RE: PZ24-00004 (SUB) Navajo Lofts

PZ24-00004 (SUB) Navajo Lofts
Planning Comments, June 13, 2024
Reviewer: Cari Meyer, Planning Manager
cmeyer@sedonaaz.gov, (928) 203-5049

Re: Comment Responses – 1st Review

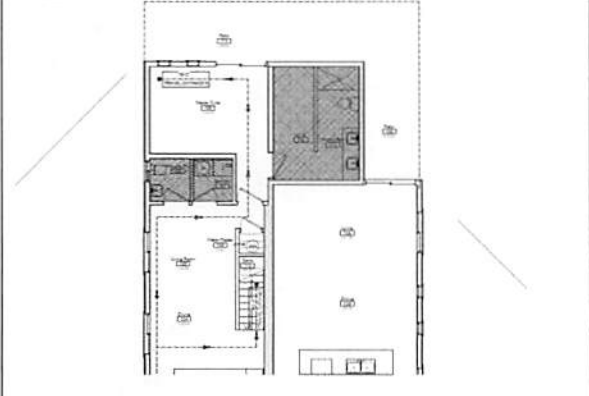
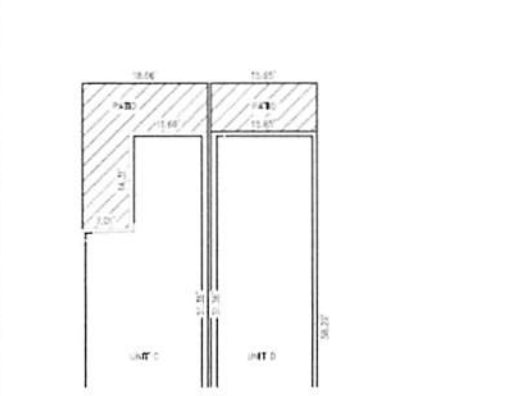
i) Unit B, Second floor: Jog in wall for mechanical room not shown on plat

4. A. Line Weights Match
 - B. Tract table added to cover sheet.
 - C. Square Foot requirements are depicted on cover sheet.
 - D. Updated on sheet 5.
 - ii-v. Updated on sheet 5.
 - vi. Sheet 5 has been updated to match approved plans.
 - vi-1. Firewall construction not shown.
 - vi-2. Shown on sheet 4.
 - vi-2 (a). Shown on sheet 4.
 - vi-3. Tracts are depicted on all sheets
 - vi-3 (a). Square feet per unit is identified on sheet 1.
 - vi-4. Utilities are shown on sheet 3.
 - vi-5. None.
 - vi-6. There are no private driveways or curb cuts. Other items shown on sheets 2-4.
 - vi-7. Shown on sheets 2-4.
 - vi-8. Shown on sheet 4.
 - vi-9. Pool, Gazebo, and Office shown on sheet 2.
 - vi-10. Garages are shown for each unit. Driveway parking is depicted in front of said garages.
 - vi-11. Shown on sheets 2-4.

Approved Plans:	Proposed Preliminary Plat

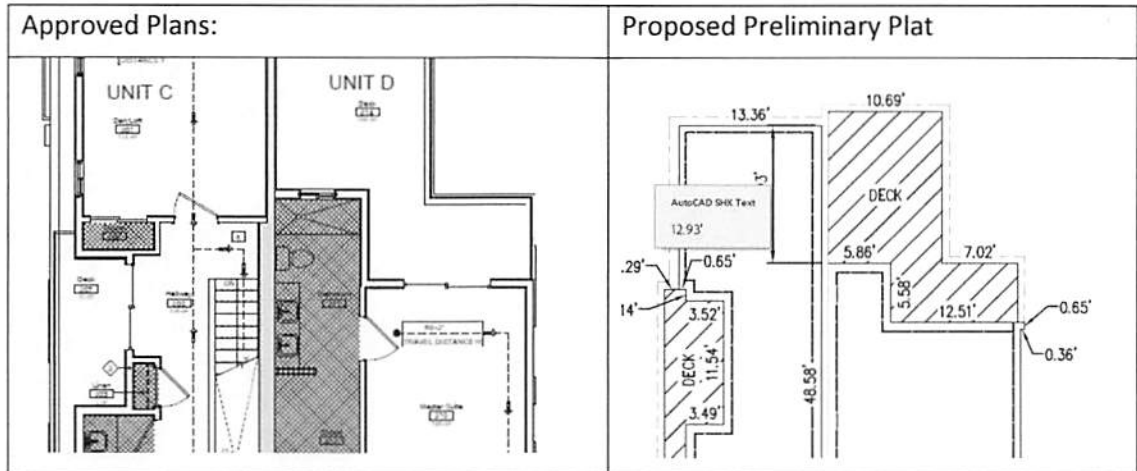
ii) Units A & C, Garages: Garage/Exterior Walls are slightly different on plans vs. plat.
